La Marzocco Technical Bulletin #91 - Friday, May 23, 2014

New filter baskets

OLD FILTER BASKET (F.3.028.GR)

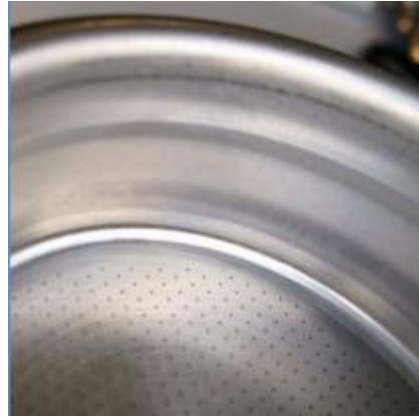
The matte finish of the new filter baskets dims the shine on the surface of the filter. The new finish will ensure the correct operating principle of Vulcano-Swift tamping since it permits Vulcano-Swift grinders, and avoids channeling along the baskets walls.

New codes as follows:

F.3.028.01 in place of F.3.028.GR (14 GR)

The previous filter baskets will be shipped with machines and parts orders until the supply has been exhausted. Please do not hesitate to contact us if you have any questions.
